EDWIN I. HATCH NUCLEAR PLANT UNIT 1

Amendment No. 10
License No. DPR-57

ATTACHMENT TO LICENSE AMENDMENT NO. 10
CHANGE NO. 10 TO THE TECHNICAL SPECIFICATIONS
FACILITY OPERATING LICENSE NO. DPR-57
DOCKET NO. 50-321

SUPPORTING AMENDMENT NO. 10 TO LICENSE NO. DPR-57

FIGURE 3.11-1 LIMITING VALUE FOR APLHGR

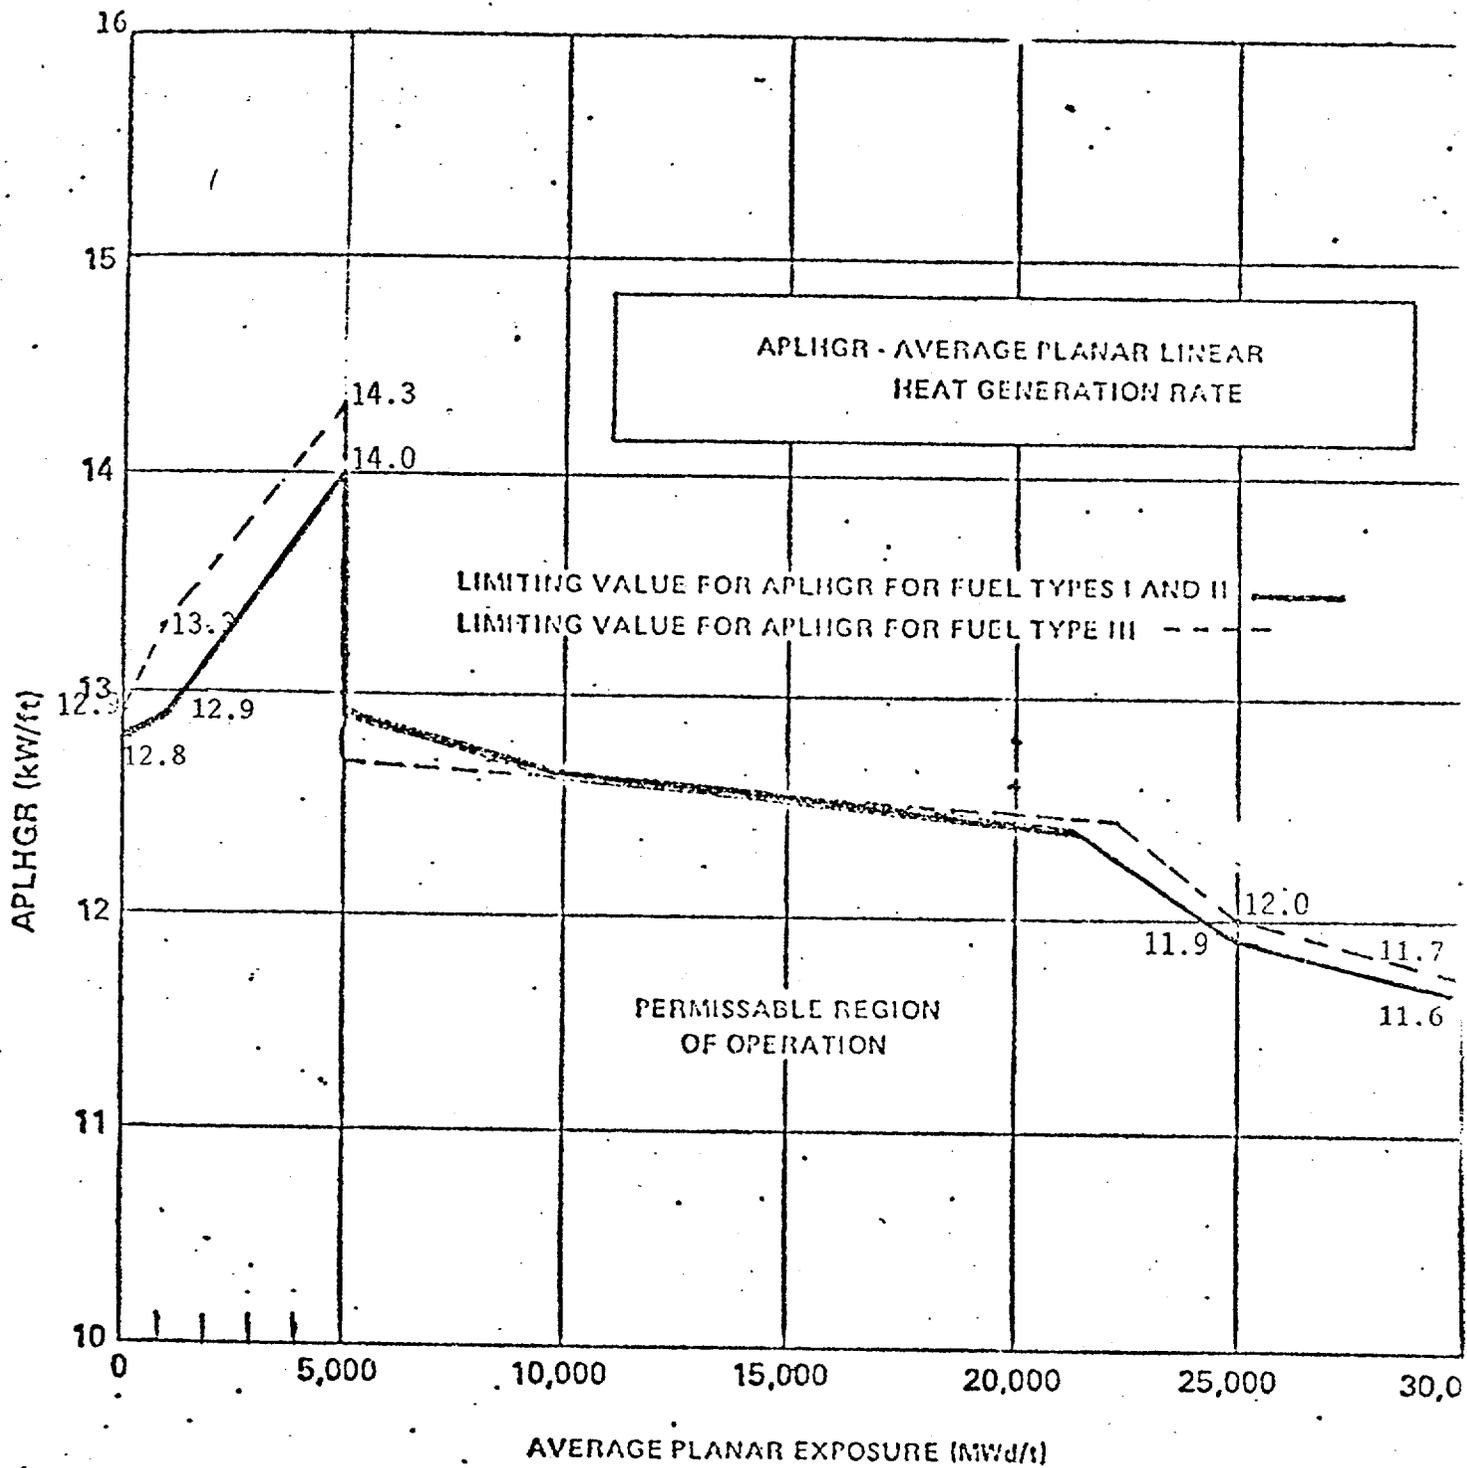
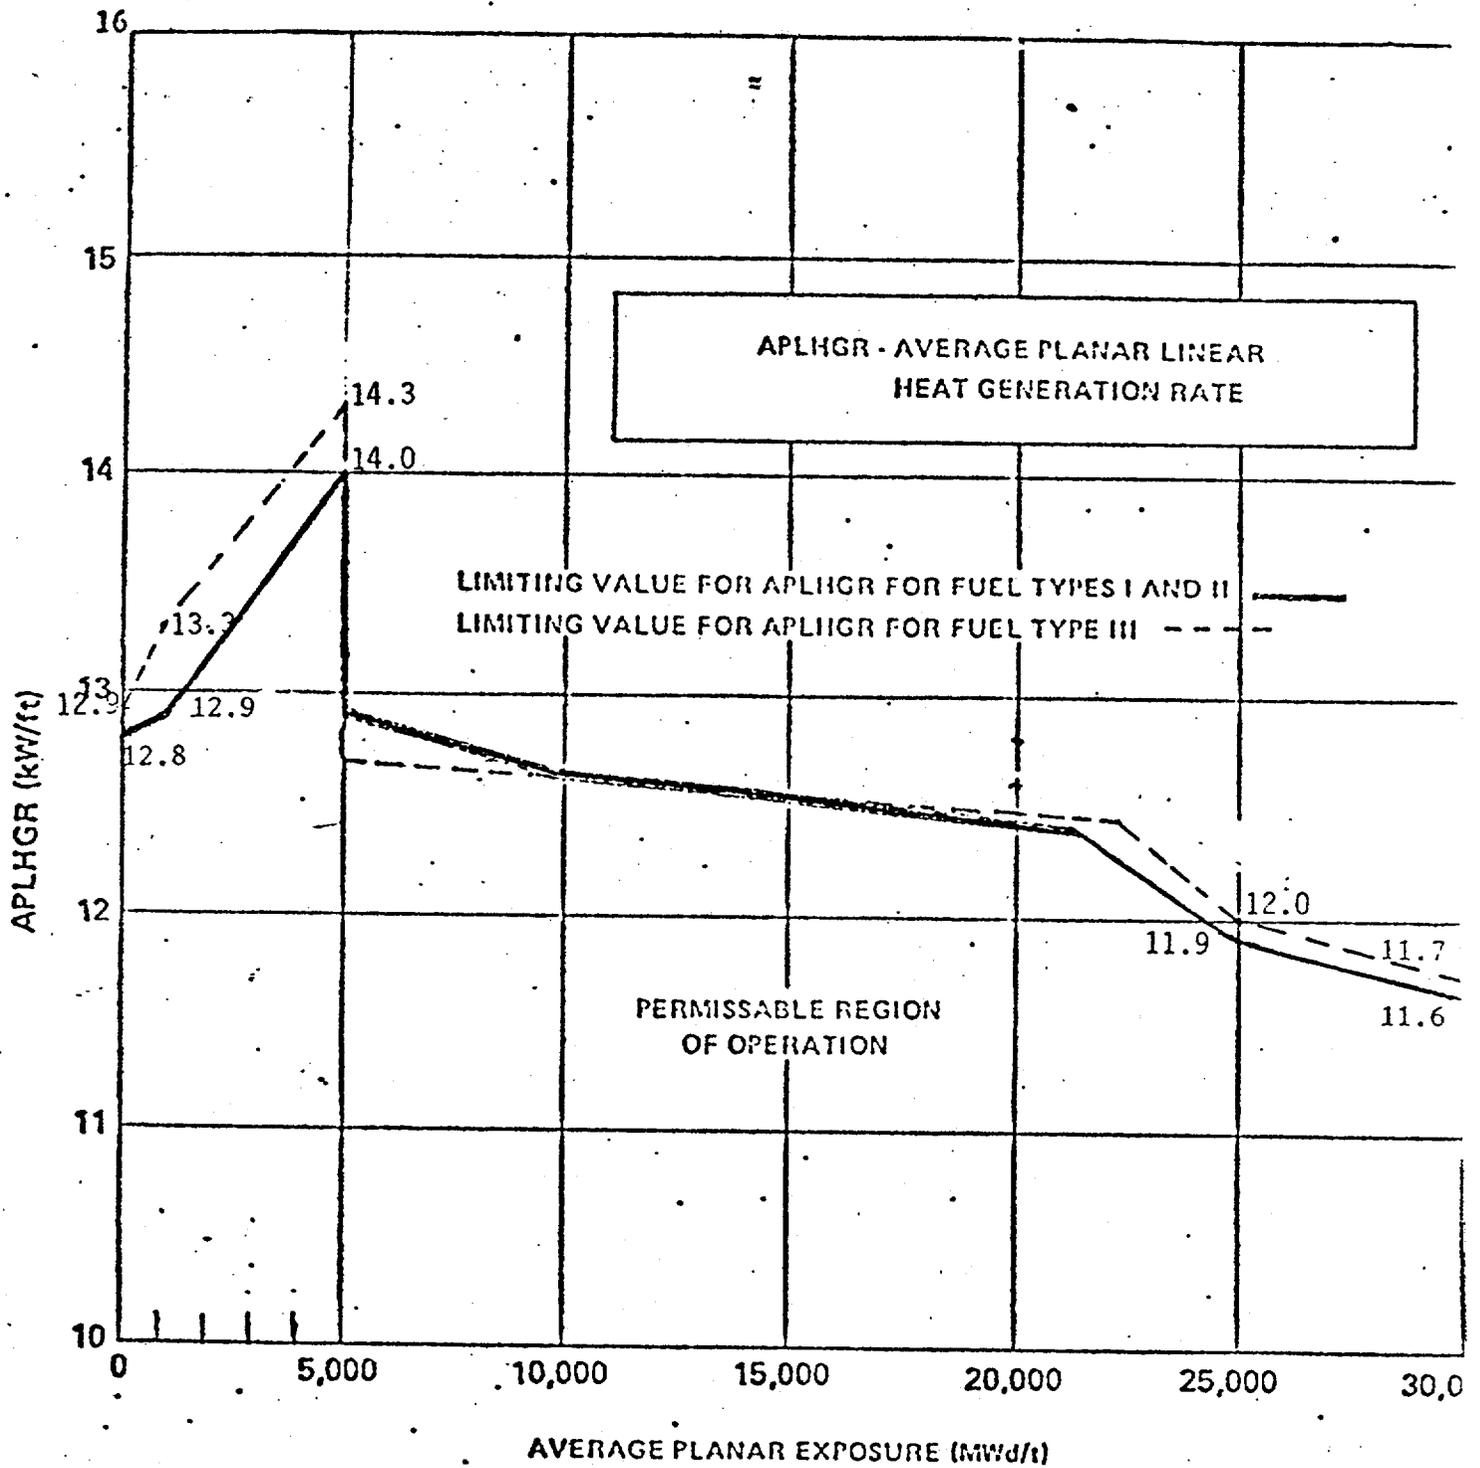
Replace Figure 3.11-1 with the attached Figure.

The limiting value for APLHGR is shown in Figure 3.11-1. That portion of the limits from 0 to 5000 MWD/T was verified using the IAC models and GEGAP III pellet-to-cladding gage conductances but is limited as shown to the values specified in Appendix A to the NRC Order of December 27, 1974. The limiting values for APLHGR for exposures greater than 5000 MWD/T is the smaller value of either (1) those specified in Appendix A to the NRC Order of December 27, 1974, or (2) those shown on the curves labeled "(gamma)" on Figures 4-9R1 and 4-9R2 of the GE topical report "Fuel Densification Effects on General Electric Boiling Water Reactor Fuel, "NEDM-10735, Supplements 6, 7, 8, August 1973, and is the result of the calculations presented in Section 4.3.4 of the same report. These calculations were made to determine the effect of densification on peak clad temperature and were performed in accordance with the AEC fuel Densification Model for BWR's which is attached to NEDM-10735, Supplement 6, 7, and 8 as Appendix B.

Upon examination, it was found that the proposed MAPLHGR curves calculated by Georgia Power Company exceed the values specified in Appendix A to the Order of December 27, 1974 over the range from 0 to 5000 MWD/T; moreover, the values currently in the Technical Specifications for the range from approximately 22,000 MWD/T and beyond are also in excess of the values specified in Appendix A to the Order. Therefore, operation over the range of burnup contemplated must be limited to the lower values specified in the December 27, 1974 Order. This correct application of the Order to the licensee's request for an amendment necessitates our modifying the proposed changes to the Technical Specifications as shown by the solid line in the attached Figure 3.11.1.

During steady state power operation, the APLHGR for each type of fuel as a function of average planar exposure shall not exceed the limiting value shown in Figure 3.11-1. If at any time during steady state power operation it is determined that the limiting value for APLHGR is being exceeded, action shall be taken immediately to restore operation to within the prescribed limits.
